Bearing in the side panel and connecting plate with an Econocraft with 7/8” journals rolls. PRB087A. 7/8” ID x 2.0” OD x 9/16 thick. Both sides

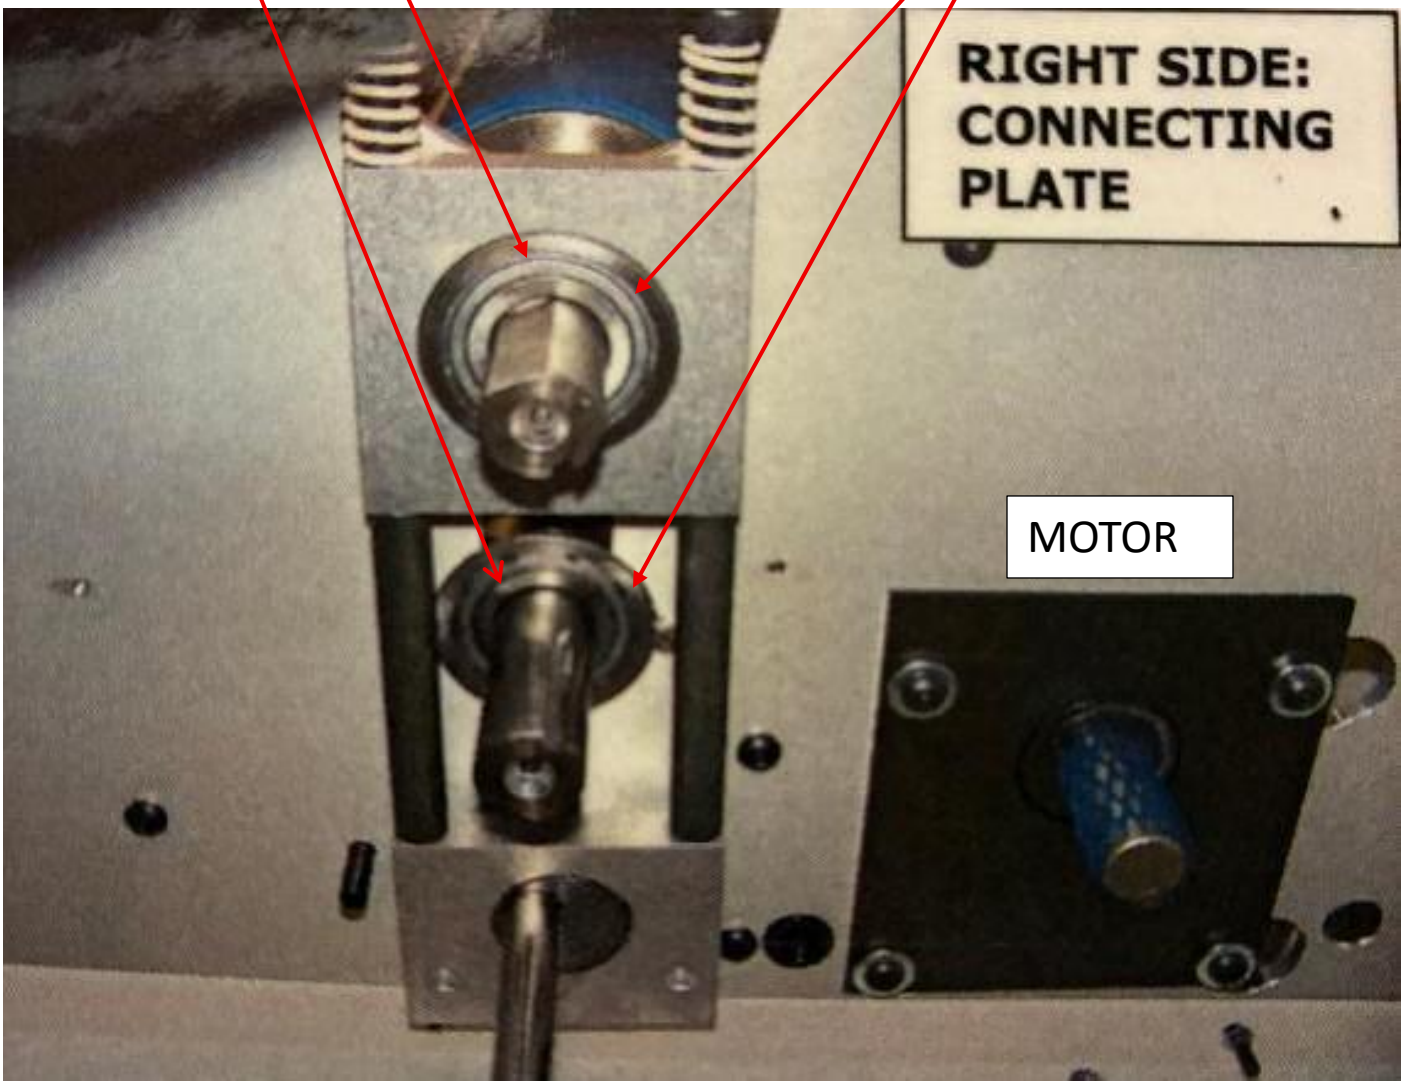
Bearing in the side panel and connecting plate with an Econocraft with 1.0” journals rolls. PRB085. 1.0” ID x 2.0” OD x ½” thick. Both sides.

If the old machine with 1.0” journals rubber rolls and is switching to 7/8” journals rubber rolls, they would need to switch the connecting plate and side panel bearings to PRB087A on both sides.

The rest of the connecting plate assemblies will work for either machine.

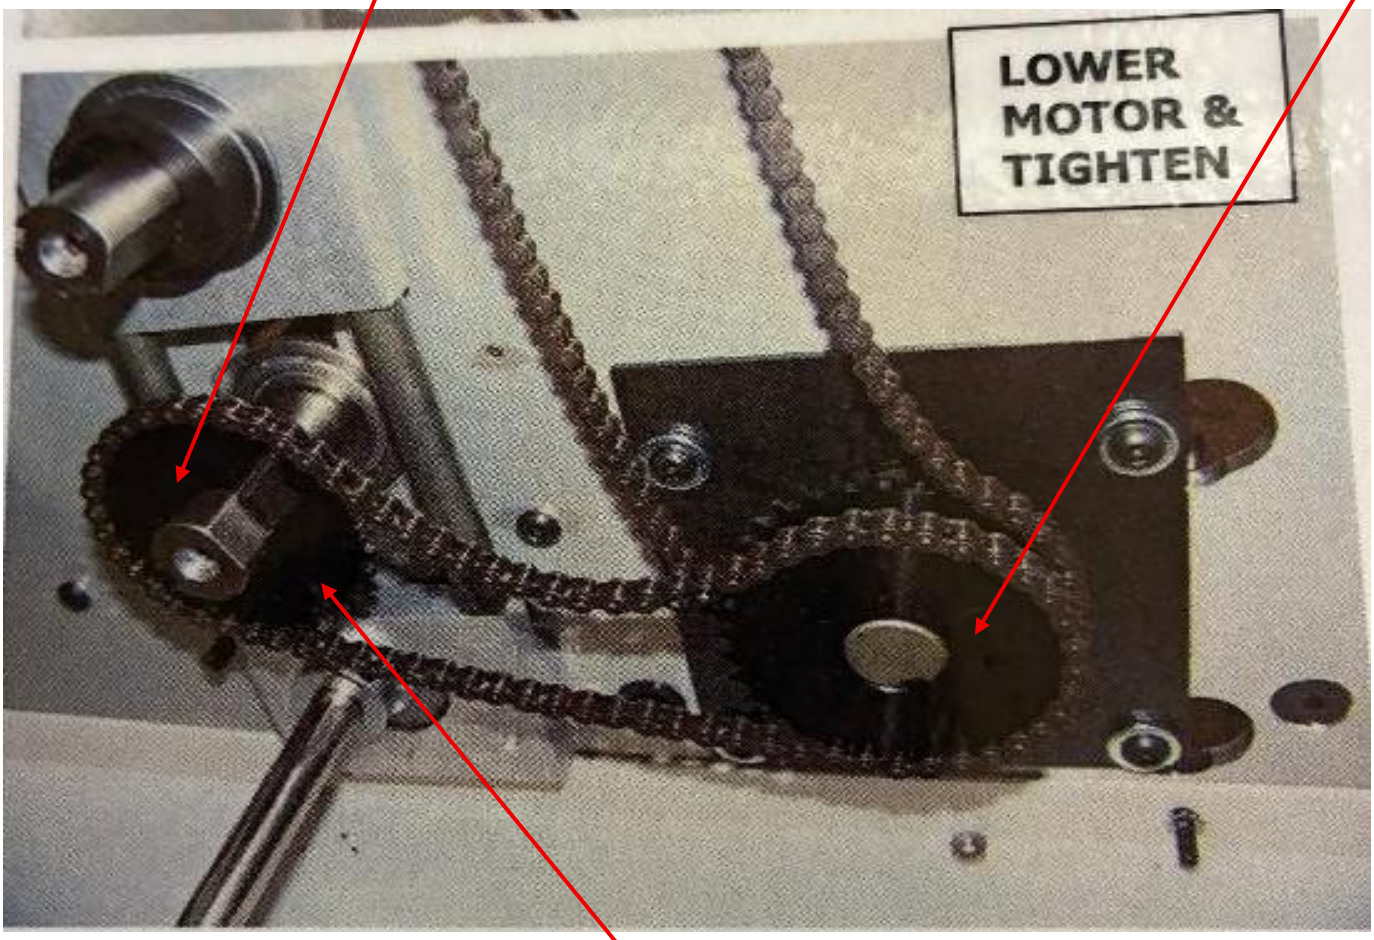
Motor drive sprockets are the same for both Econocraft machines with 7/8” or 1.0” journal rolls. PRS25A. 25B32 with ¾” bore sprocket. (2) Right side.

Bottom rubber roll drive sprocket for Econocraft with 7/8” journals rolls. PRS258C. 25B32 with 7/8” bore sprocket. Right side.

Bottom rubber roll drive sprocket for Econocraft with 1.0” journals rolls. PRS258B. 25B32 with 1.0” bore sprocket. Right Side.

To change the Econocraft from 1.0” journal rolls to 7/8” journal rolls they would need new bottom rubber roll drive sprocket PRS25C. (1) Chains would be the same for both machines. The upper Release Liner drive would be the same for both machines.

Rubber roll sprockets for Econocraft with 7/8” journals rolls. PRS258C. 25B32 with 7/8” bore sprocket. (2) Left side

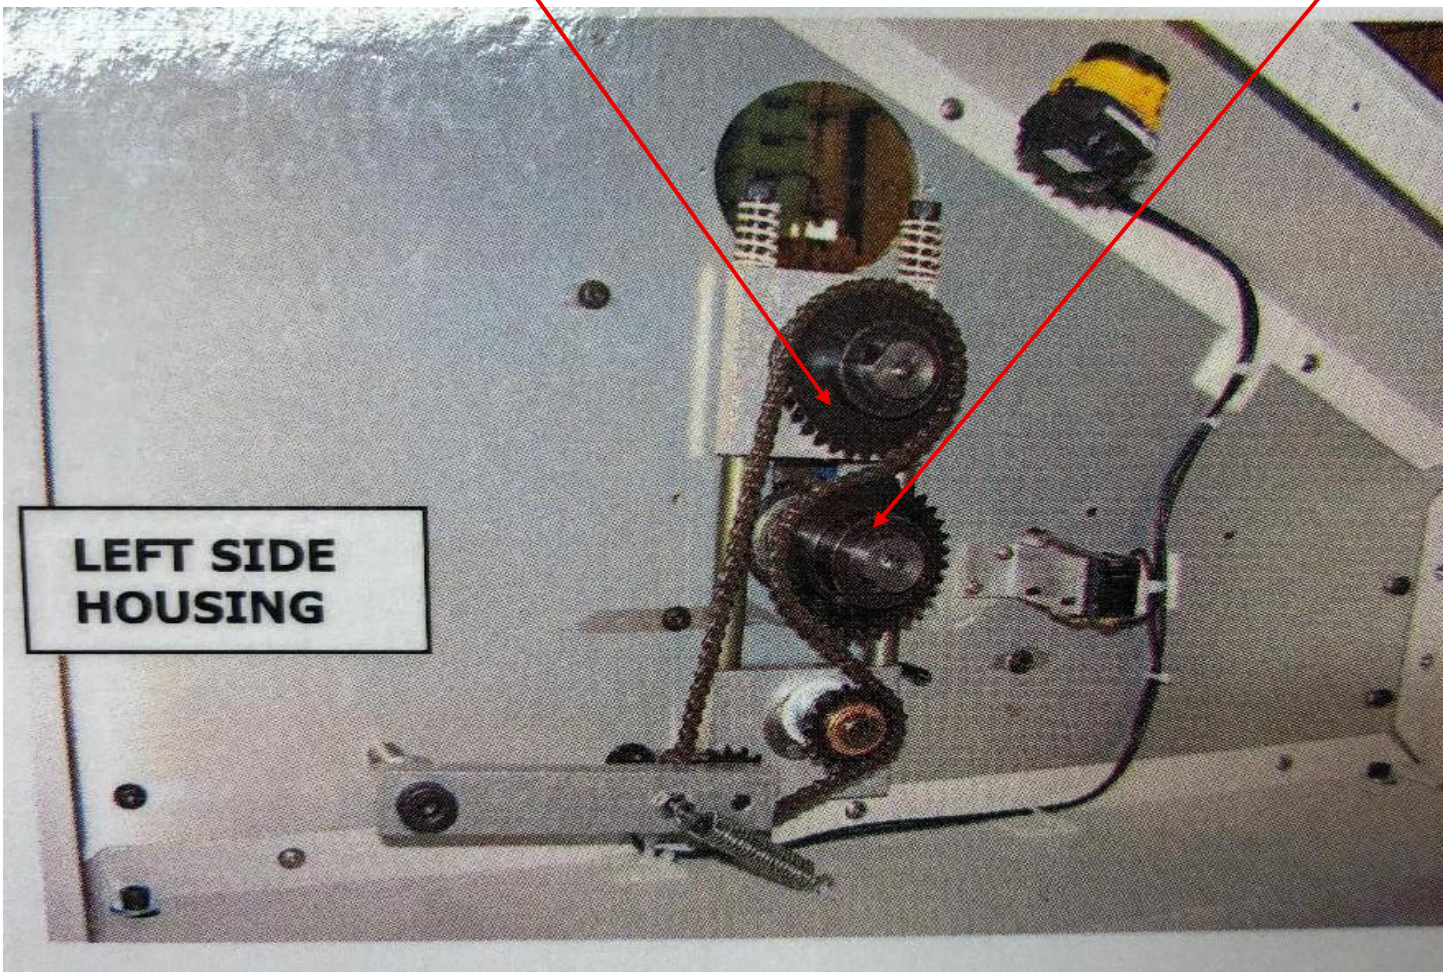
Rubber roll sprockets for Econocraft with 1.0” journals rolls. PRS258B. 25B32 with 1.0” bore sprocket. (2) Left side.

To change the Econocraft from 1.0” journal rolls to 7/8” journal rolls they would need new top and bottom rubber roll sprockets PRS25C. (2) Chains would be the same for both machines. Tensioner would be the same for both machines.

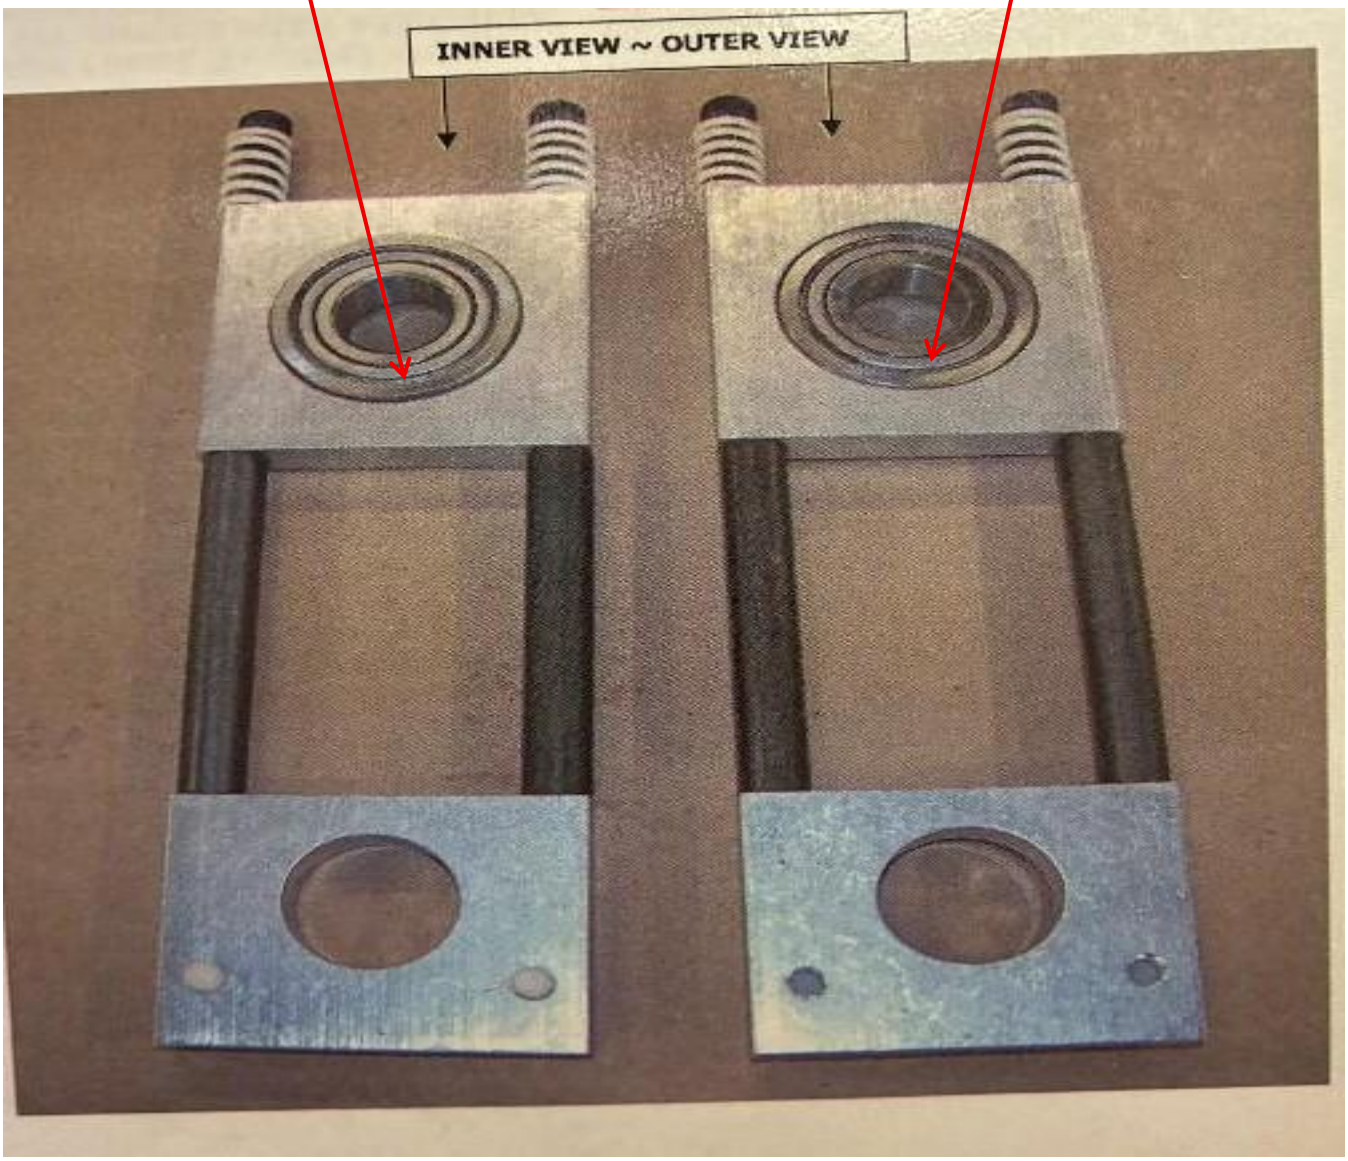
Bearing for a new Econocraft with a 7/8” journal. PRB087A. 7/8” ID x 2.0” OD x 9/16 thick. Both Sides.

Bearing for an old Econocraft with 1.0” journal. PRB085. 1.0” ID x 2.0” OD x ½” thick. Both sides.

If the old machine with 1.0” journals rubber rolls and is switching to 7/8” journals rubber rolls, they would need to switch connecting plate bearings to PRB087A on both sides.

The rest of the connecting plate assemblies will work for either machine.
